## SUMMARY OF AMENDMENTS

277A Gray's Inn Road, London  
October 2016

**WAUGH THISTLETON**

Extract of proposed ground floor plan with areas of loss and recoup highlighted

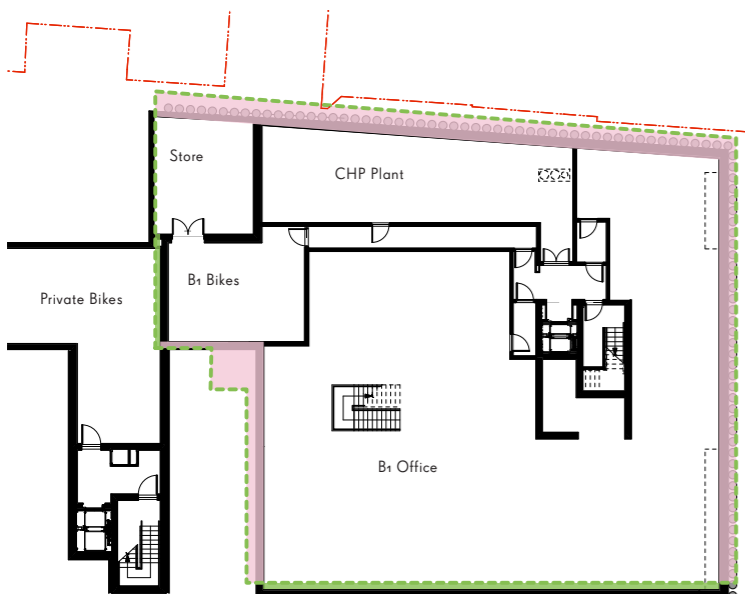
In some areas of the consented scheme, the required thickness of basement structure, allowing for the required performance, is as much as 1,550mm. The structure shown at planning is typically around 600mm but in some places decreases to zero.

In order to accommodate the wall thickness required to successfully and safely build the principles of the consented scheme, the basement needed to be reconfigured. To accommodate a similar amount of gross internal area as consented, the proportion of site area covered by the basement has increased.

- The total gross internal B1 area has had to be decreased by 7.4sqm
- The total let-able A3 area has been increased by 2.4sqm
- The total area allocated to the residents' gym has decreased
- The number of cycle storage spaces has been maintained
- Plant space has been allocated in accordance with a detailed design
- The SUDS strategy has been revised to minimize the impact
- The overall gross internal area of non-residential space in this core has decreased by 51.9sqm

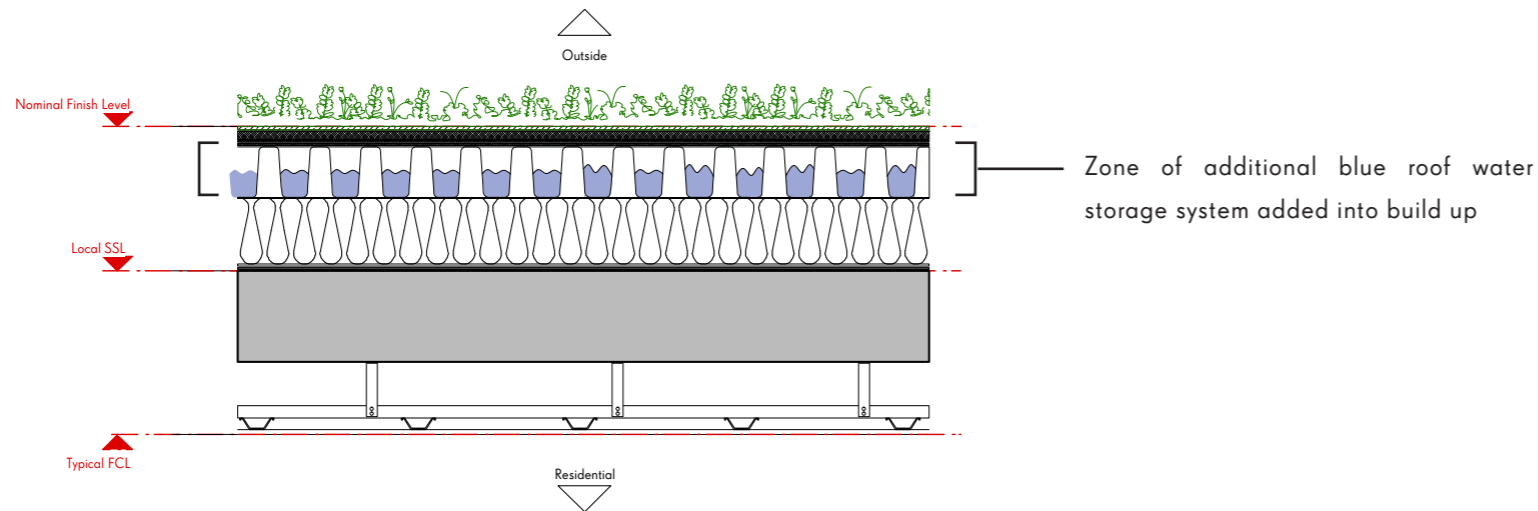
The B<sub>1</sub> cycle storage is still located at basement level and is still accessed directly from the B<sub>1</sub> accommodation.

The cycle storage for RSL flats has been moved from the basement to the 'undercroft' area at ground floor where the site is accessed from Gray's Inn Road. This will be in the form of permanent lockers with individual key access.

With the thickening of the basement structure, it was no longer possible to maintain the location of the store as shown in the consent as the increased wall thickness closed off the corridor between the office space to the west and east of the core. Coupled with the essential relocation of the plant room, this left a non-viable 'pocket' of B<sub>1</sub> space in the basement.

Locations of 'blue roof' replacing SUDS tanks

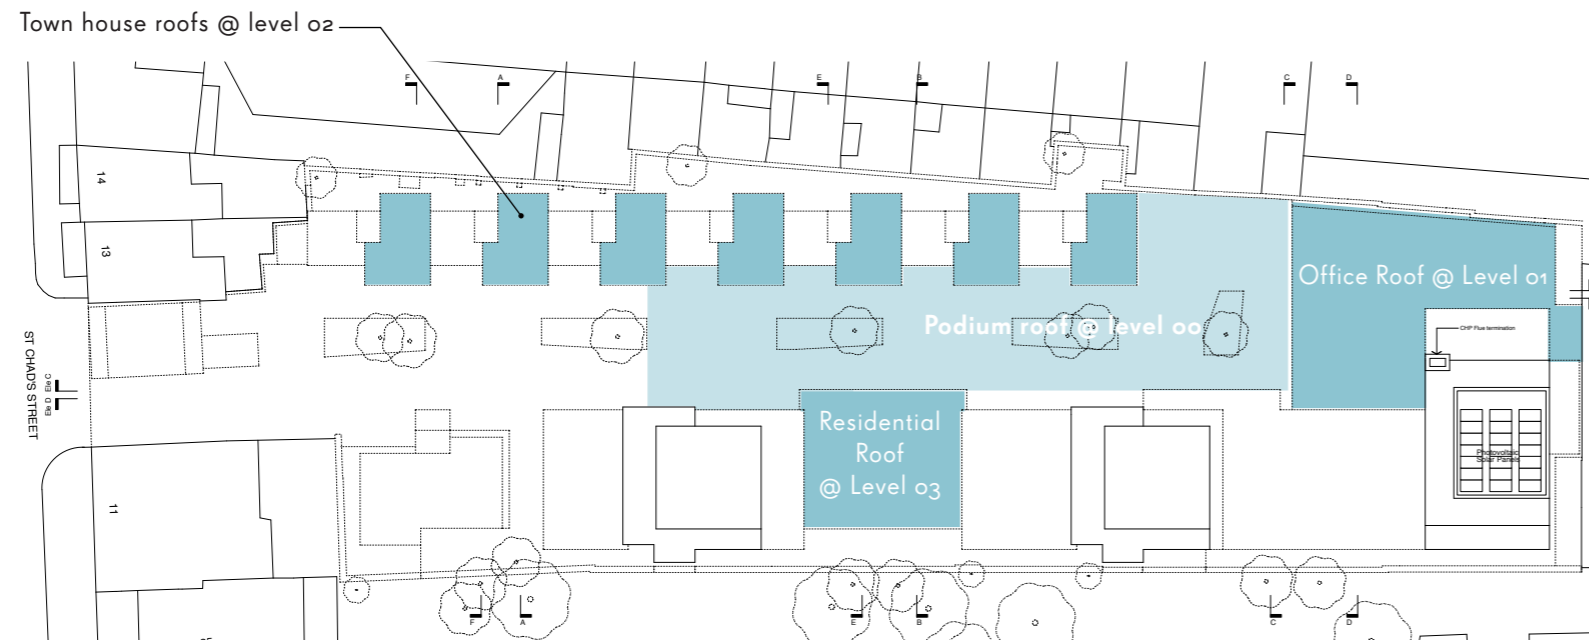
The attenuated water will no longer be stored below ground. This storage will be replaced by 'egg crate' layers within the roof build-ups.

The water will be stored within the zone of the build up of the ground floor deck in the mews (over the basement box) and within the roof build ups at first floor level. It will then be released at an attenuated rate into the drainage system using adapted rainwater outlets. The levels at ground floor will not be altered. The height of roofs at first floor will increase slightly.

- The same volume of water storage as the consent
- The same flow rate of release into the mains system
- No change to ground floor levels
- Minor increase to roof heights in some locations (see left) of 150mm.

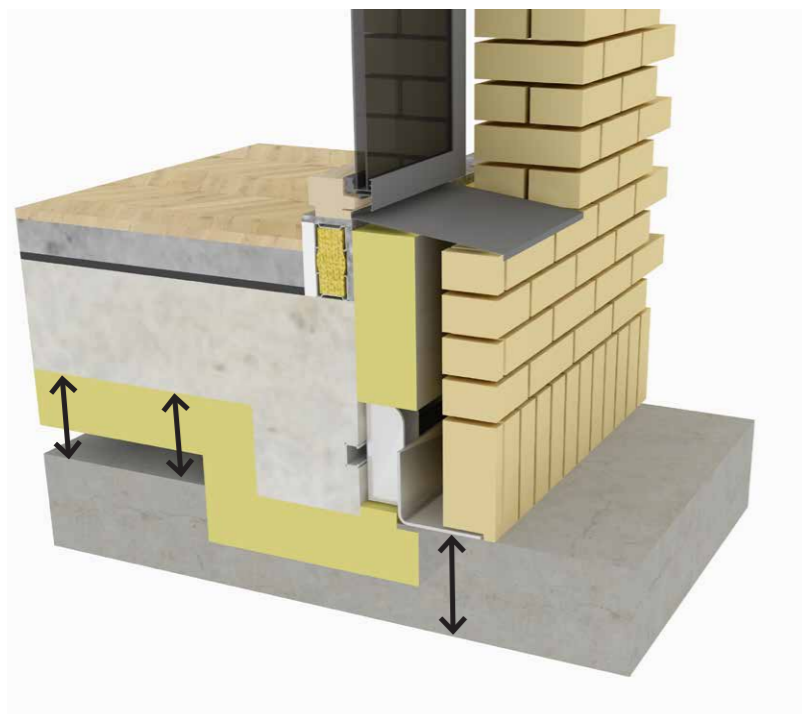
The high level cladding to the main accommodation floors and to the mansard roof on St. Chad's Street are referred to in the planning consent elevations as 'anodised aluminium' and shown in a gold colour. We are concerned that anodised aluminium is not a suitable material for some parts of the roof.

In the location of the mansard, the system would need to be a sealed system rather than an open rain screen that would be applied in the rest of the facade. Aluminium roofs of this type are normally associated with light industrial buildings. We are concerned that a metallic anodised finish will be difficult to achieve with a system / contractor more used to circumstances where appearance is not the primary concern. We believe that the strategy of unifying the roof elements in a single colour / material is correct, but if the material chosen is not suitable for one part of the roof then a new material should be chosen for all the 'gold anodised' elements.

We also have concerns that a gold anodised finish will provide unacceptable levels of reflection when used at high levels across large surfaces.

Finally, a concern is that an anodised finish, particularly in metal effect, is easily prone to damage, for example by bird strike, but is notoriously difficult to patch up.

To resolve these problems, we propose to use a coloured zinc cladding with standing seams. Similar to the proposed anodised aluminium but without reflectiveness. It is robust, durable and is a more traditional roofing material which is suitable for use both on vertical surfaces and on the inclined roof of the St. Chad's Street mansard.

The issue of offset concrete elements leading to the proposal for replacement by fibre C

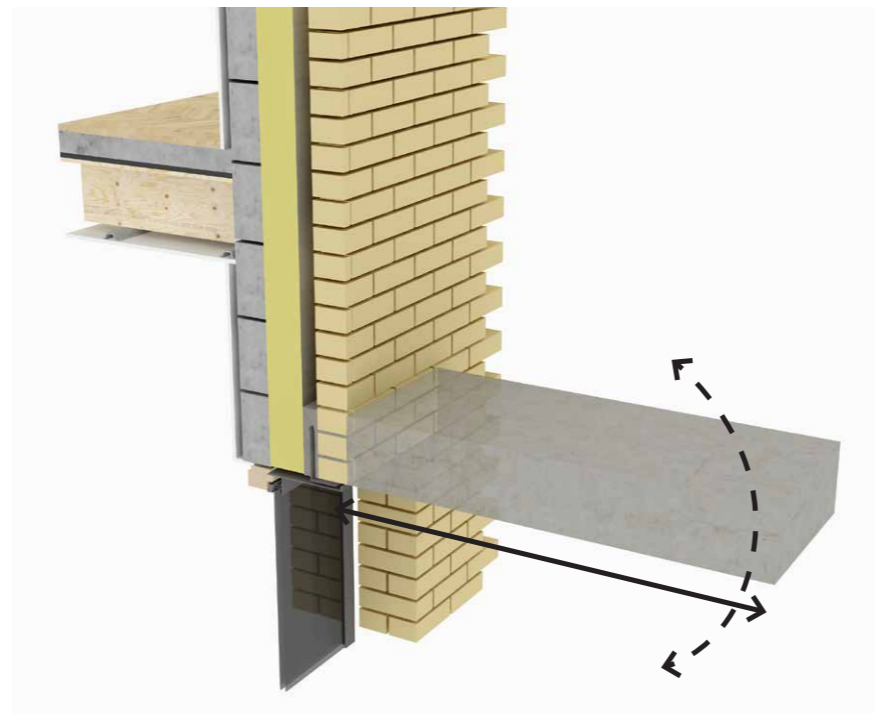
The issue of large cantilevers to concrete elements leading to the proposal for replacement by fibre C

● Area of concrete proposed to be replaced with brick

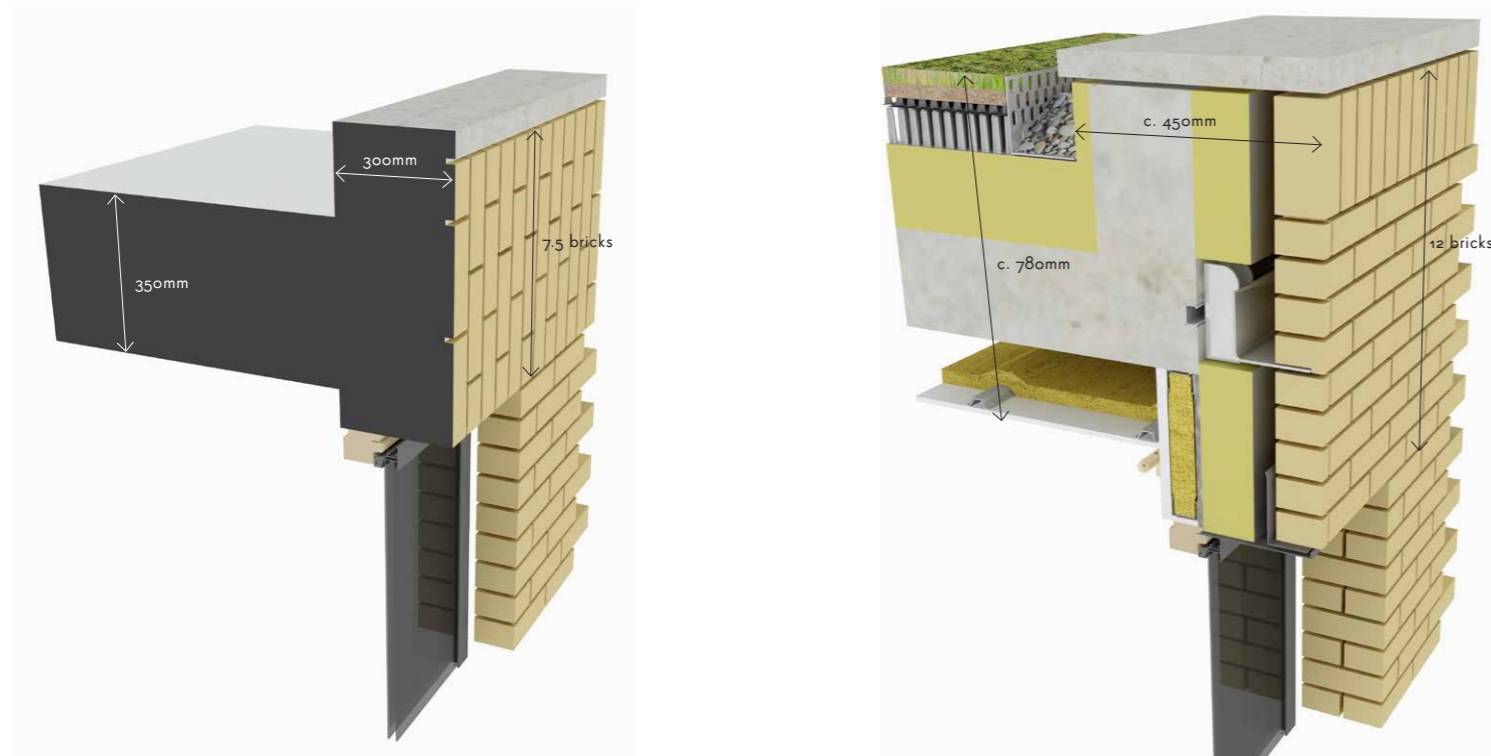
The two extracts above show how build-ability issues have changed the proportion of the parapet detail from planning (left) to construction (right) necessitating review of the brick detailing strategy.

Extract from consent showing a full height, clear glass window against shower tray

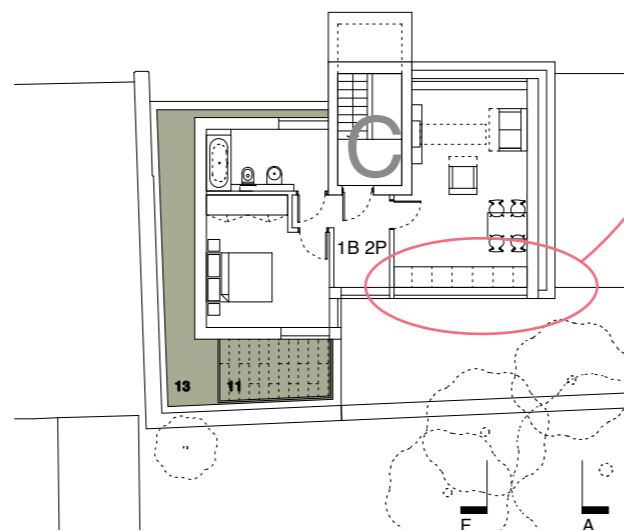
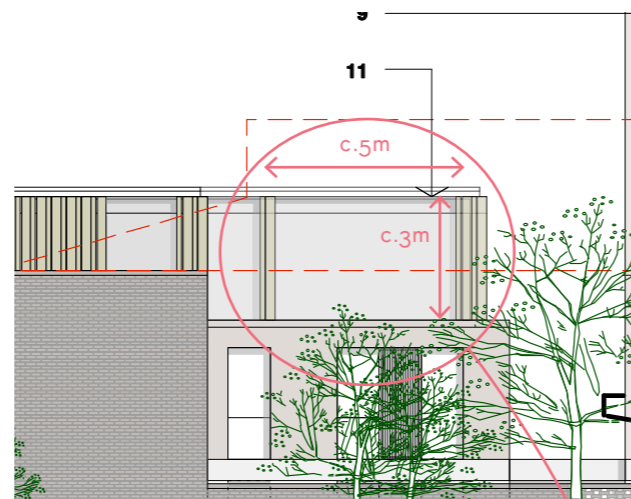
Extract from consent showing very large window in accessible area of the site. It is shown as clear with no mullions or transoms but in plan is shown with a full kitchen behind.
